DESIGN ADVISORY BOARD Tuesday November 23, 2021 3:00 PM

DESIGN ADVISORY BOARD

To: The Design Advisory Board
From: Mary O'Neil, AICP, Principal Planner
RE: ZP21-509 72-76 Elmwood Avenue
Date: November 23, 2021

To: The Design Advisory Board
From: Mary O'Neil, AICP, Principal Planner
RE: 111 North Winooski Avenue ZP21-606
Date: November 23, 2021

DRAWING TITLE	
OBJECT NO.	2020-1
DATE:	11/15/20
SCALE :	AS-NOTE
DRAWN BY :	WJR/MF

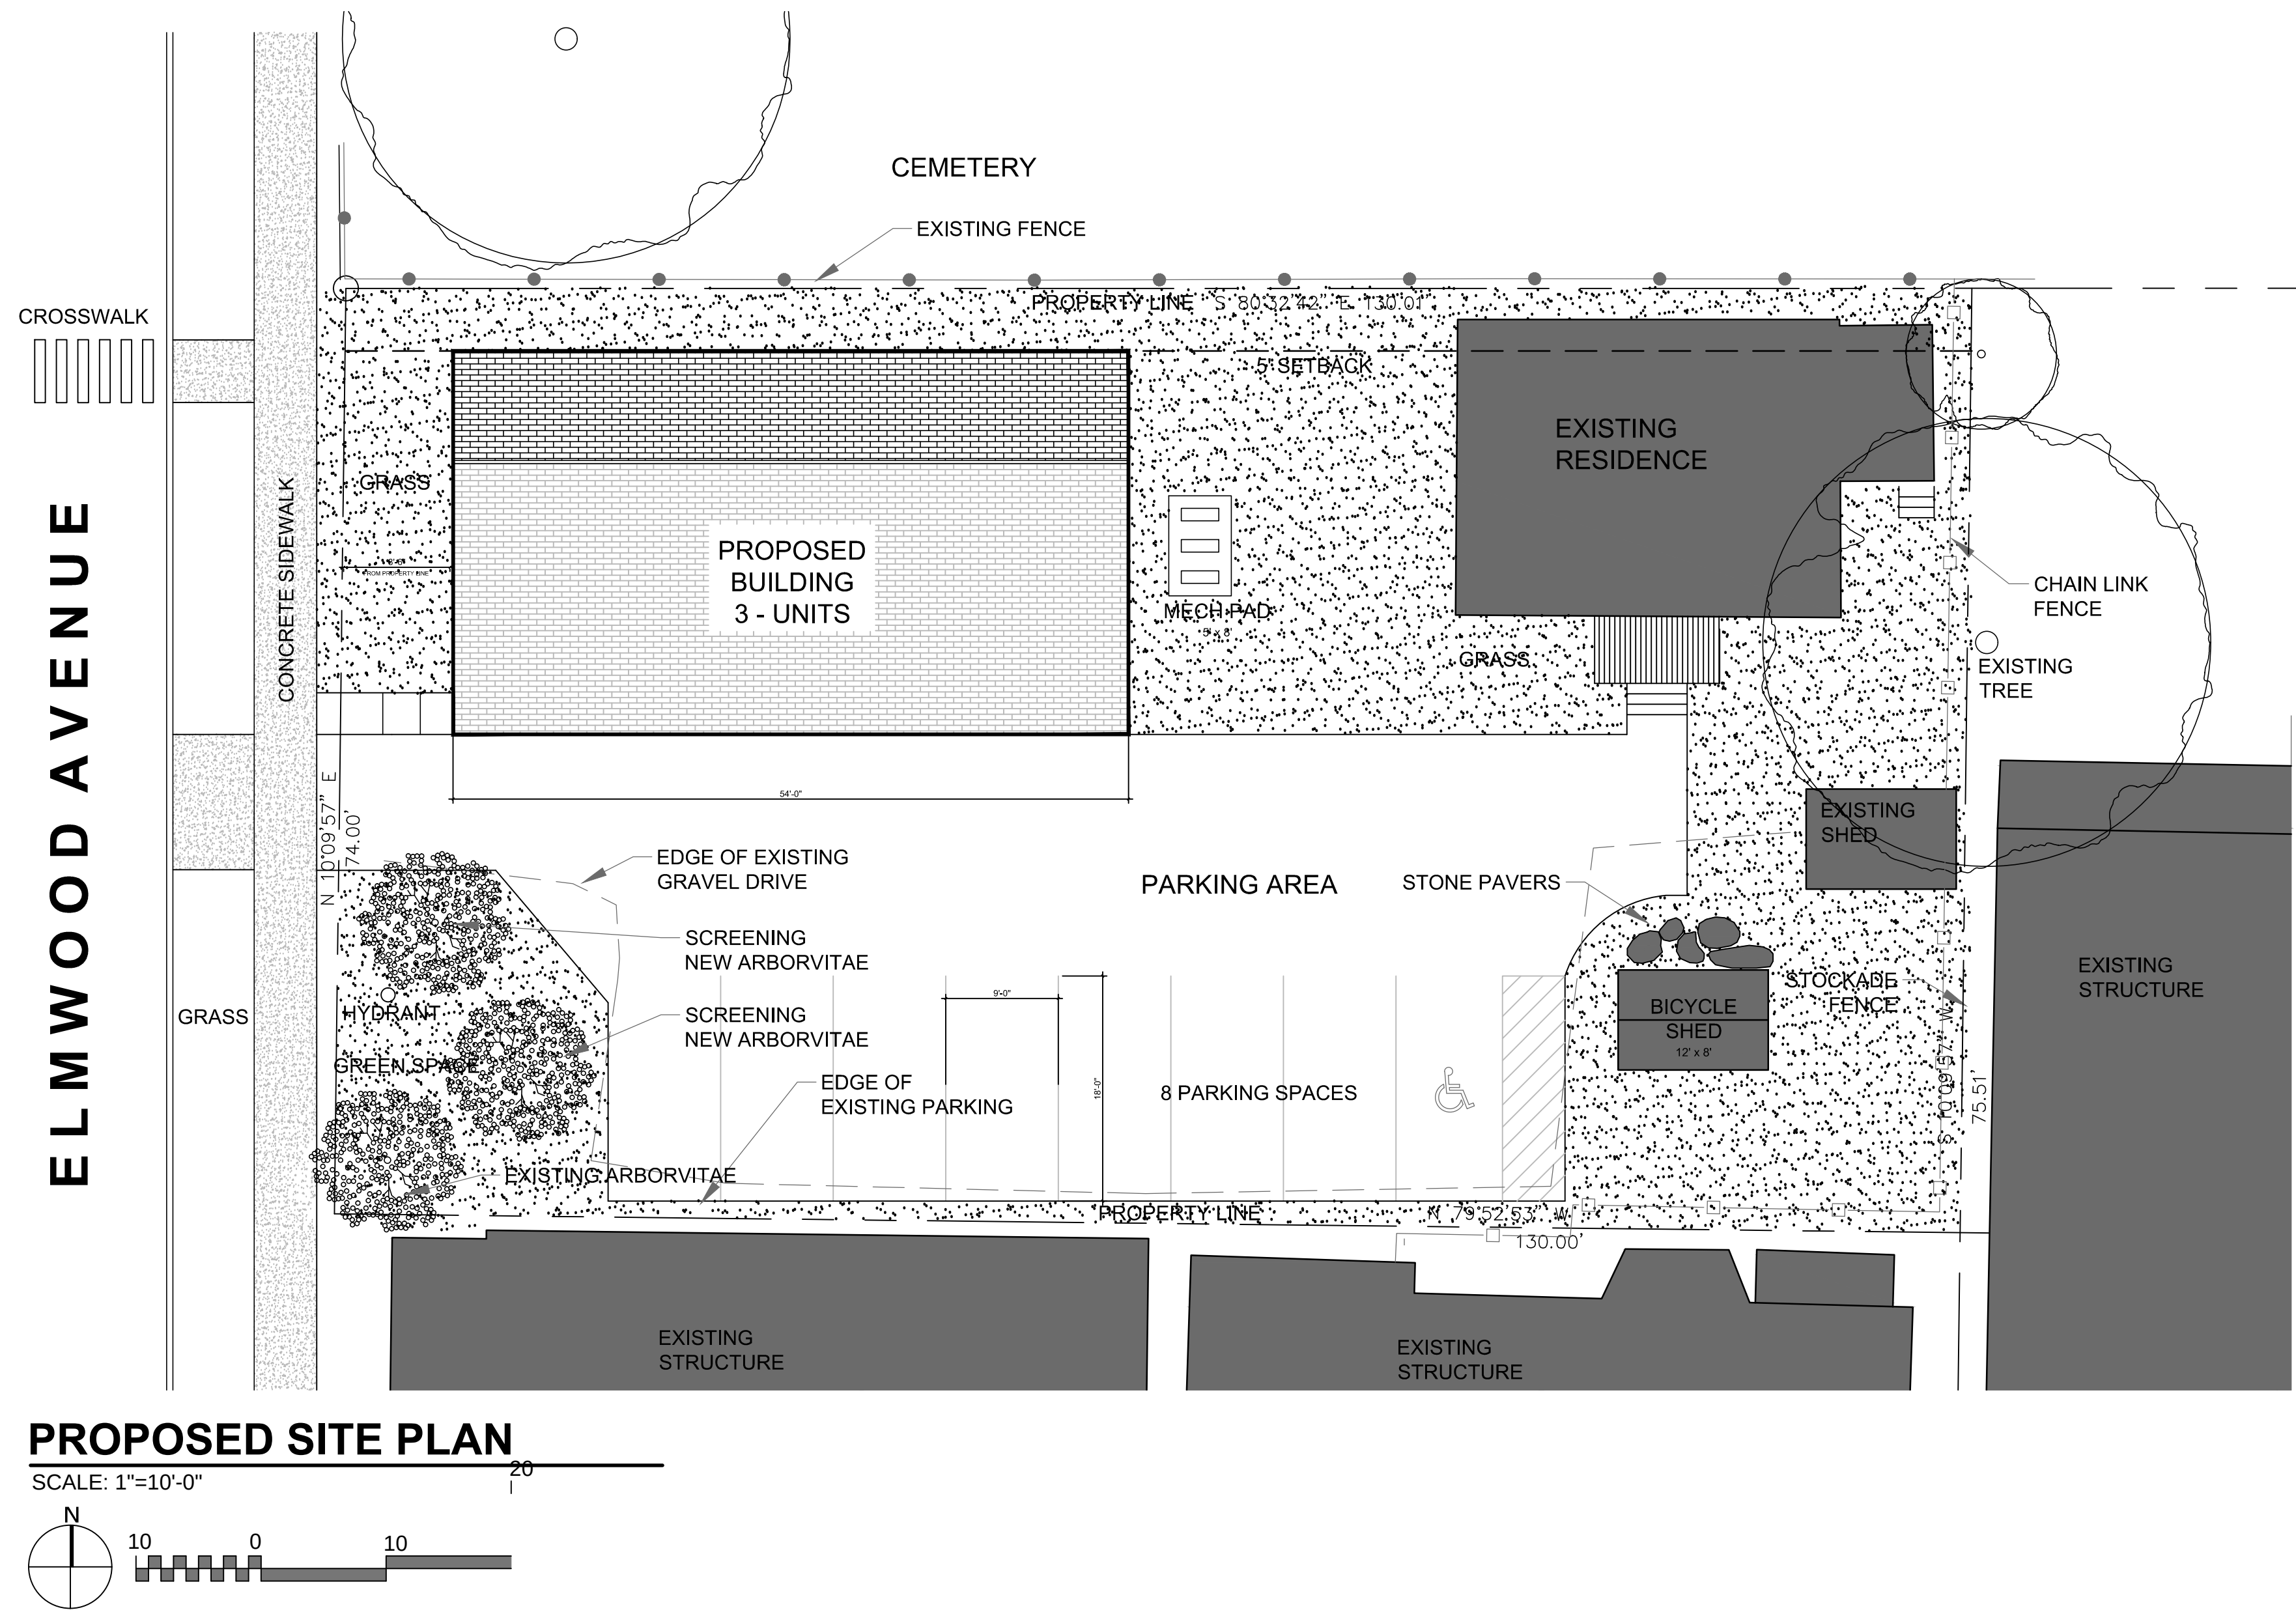
- Plans for the Bicycle Shed and Condensing equipment shall be provided.
- Plan L-100 sets the north elevation of the new building exactly 5' from the property line. Plan A-200 places decks within the 5' setback. Unless the applicant can establish that the average north setback (taken from 68 Elmwood Avenue) is less than 5', the decks are an encroachment into a minimum required setback and cannot be included.

4-400 | WEST ELEVATION

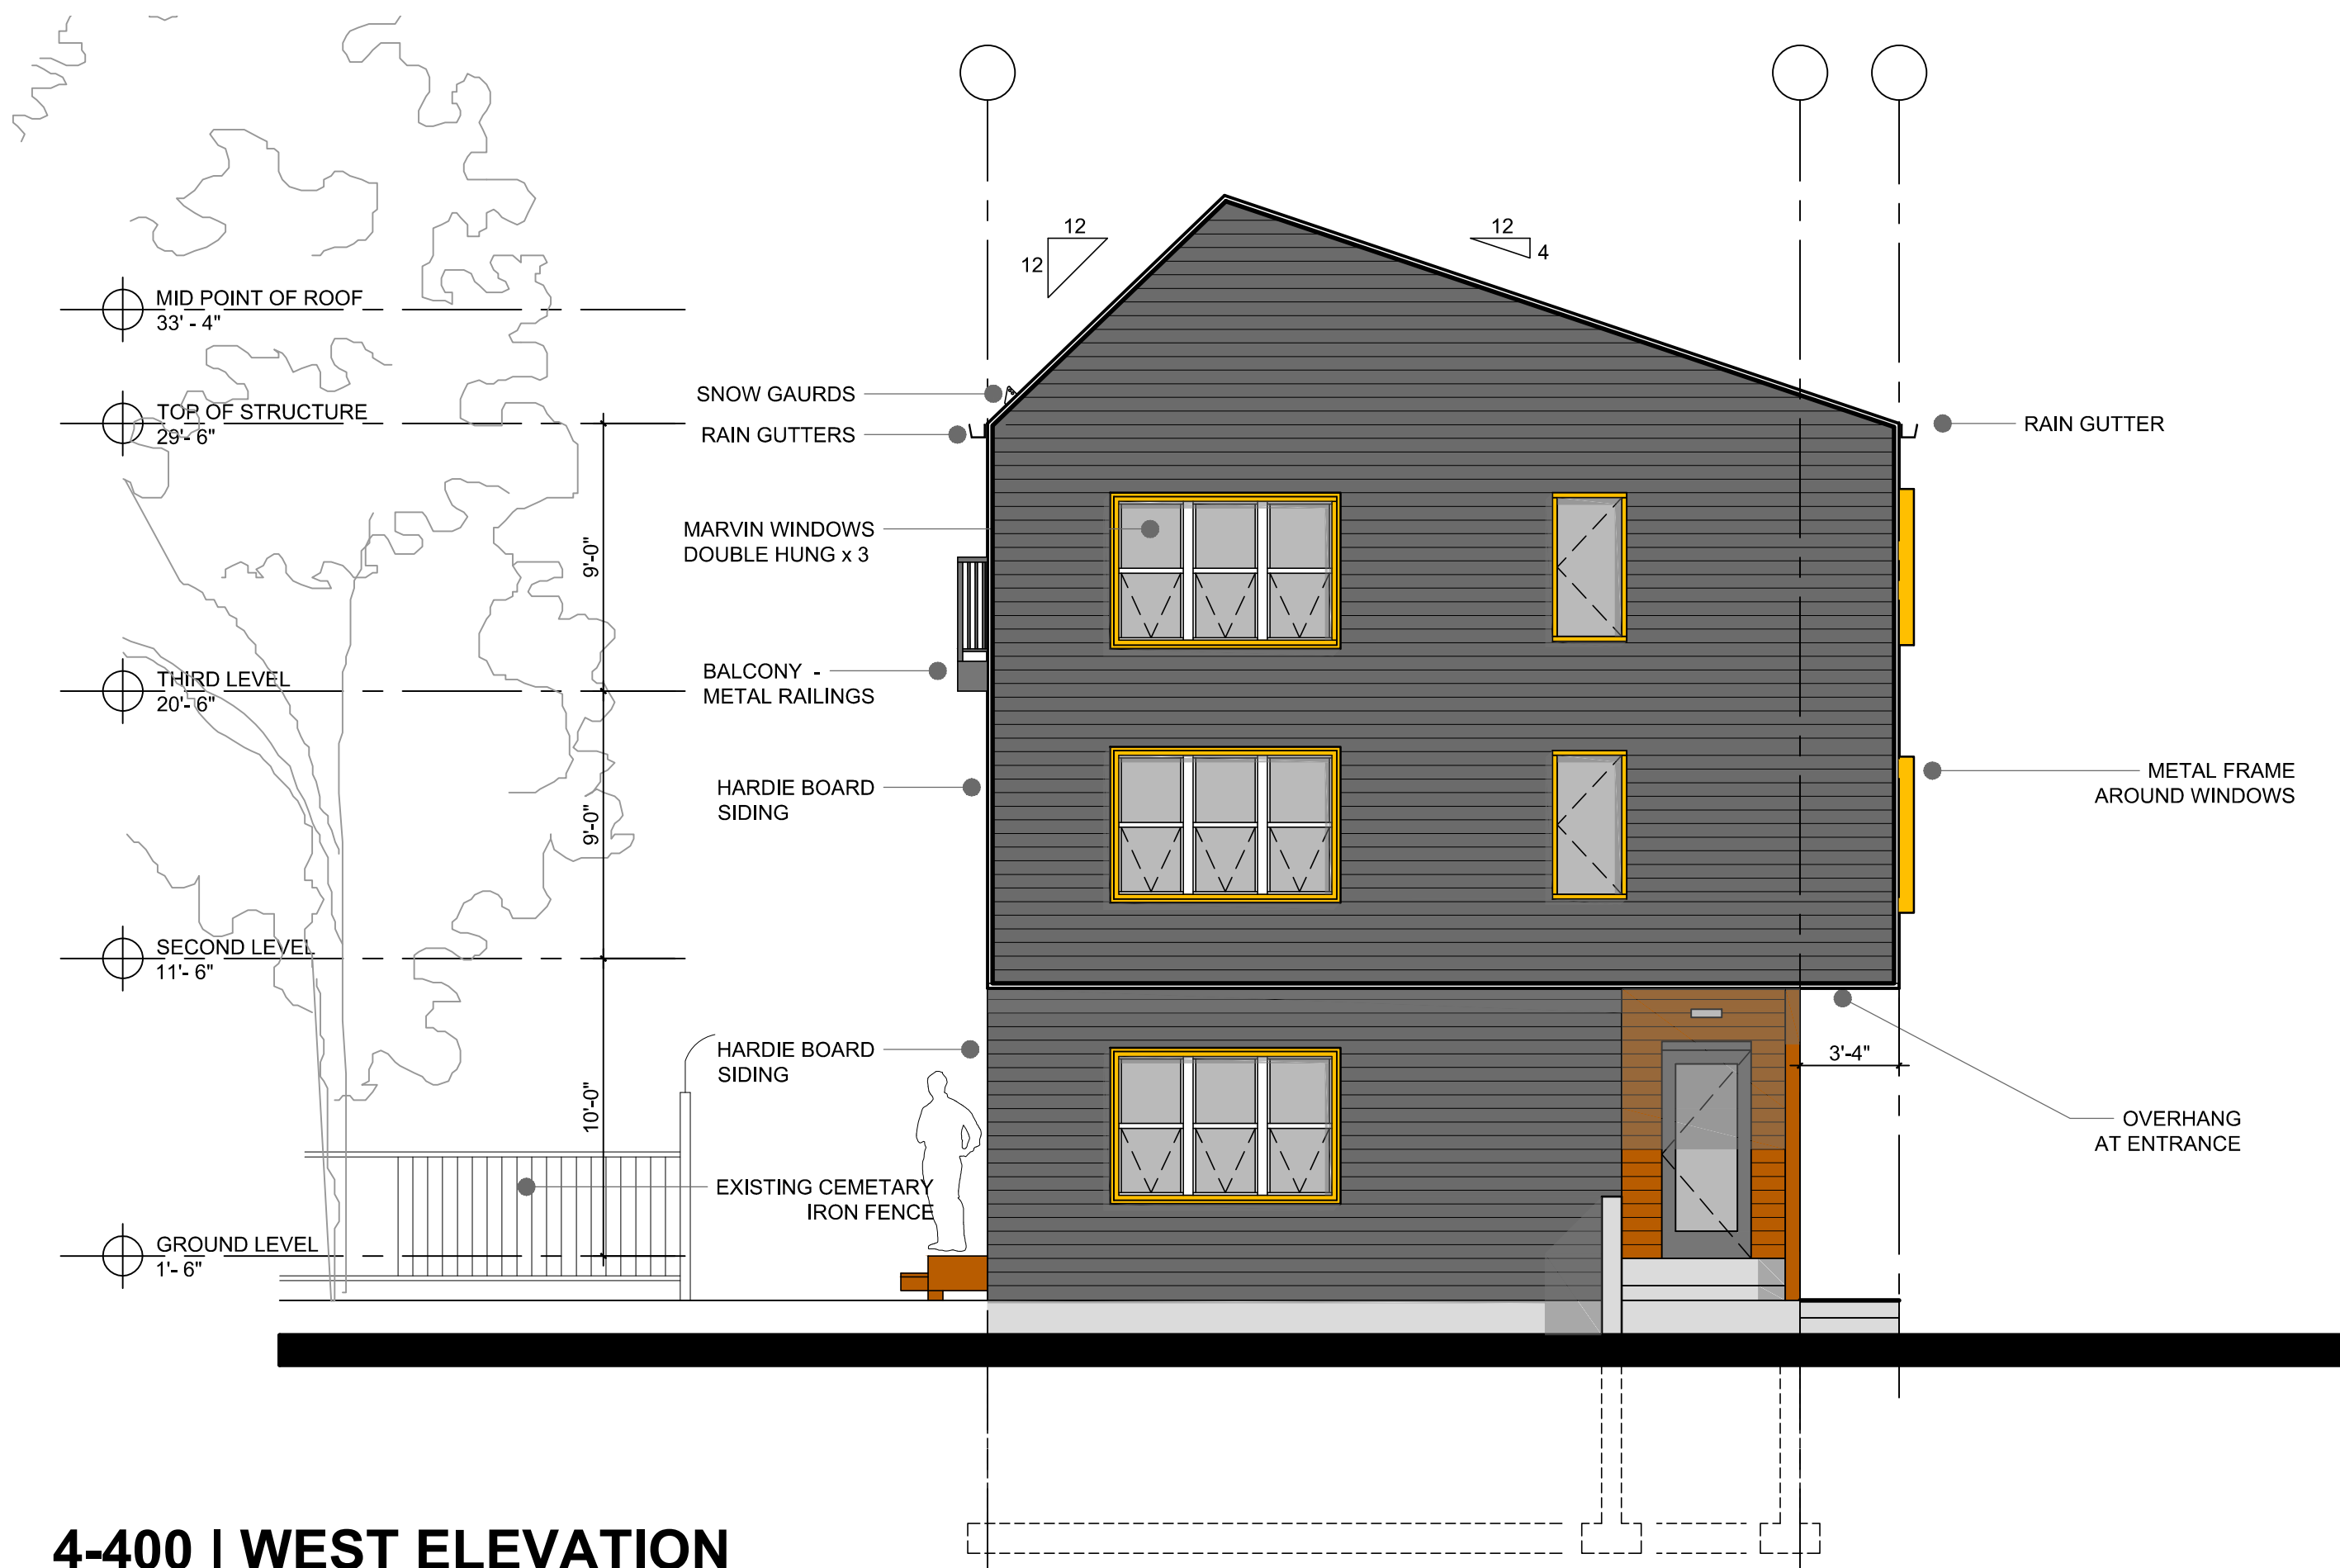
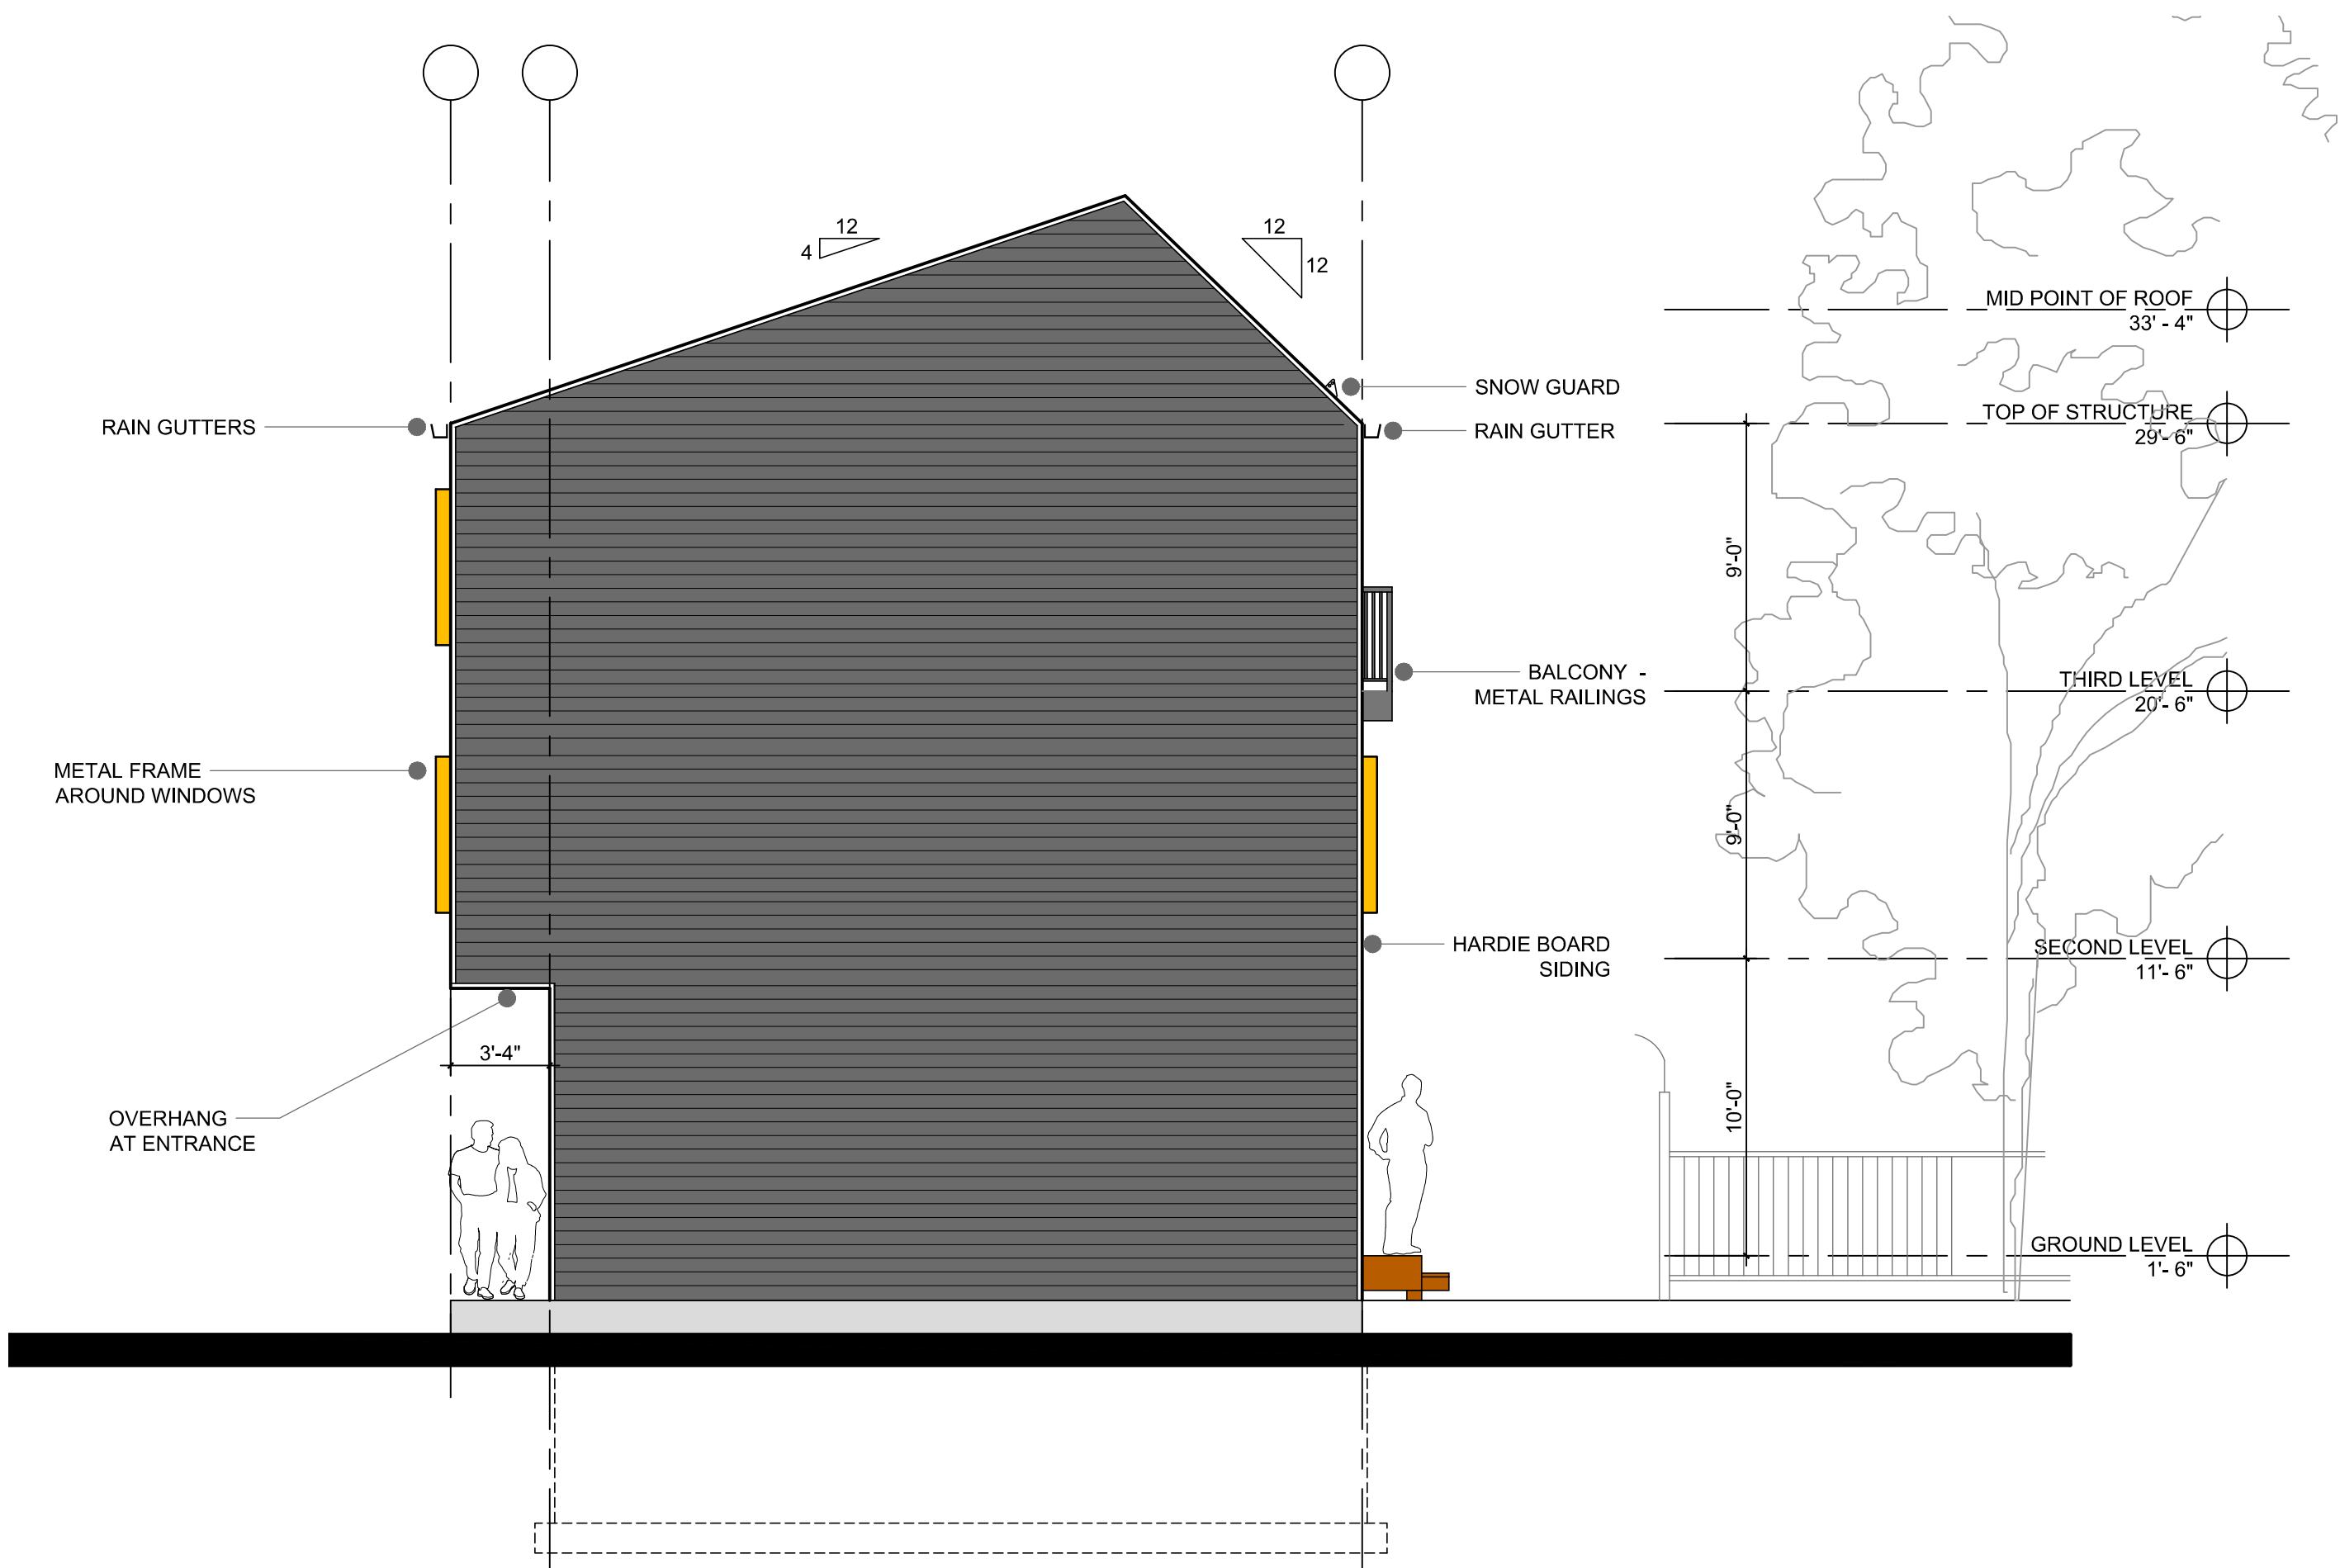
The proposed building has a modified cat-slide roof with dual pitch and zero eave extrusion. Responding to DAB comments, snow guards and rain gutters have been added on the north and south elevations. In style it reads as a modern infill.

As designed, the building lacks typical façade articulation such as bays, horizontal and vertical façade articulation, porches, patios, articulated bases, step-backs or other street level details. Windows are stacked, however, providing a measure of arrangement. The plan is modernistic with a simplified form and little detailing. The only interest provided is the angular and asymmetrical roof line, and “framed” window surrounds. Revisions include a differentiated first floor south and west entry, as requested by the Design Advisory Board.
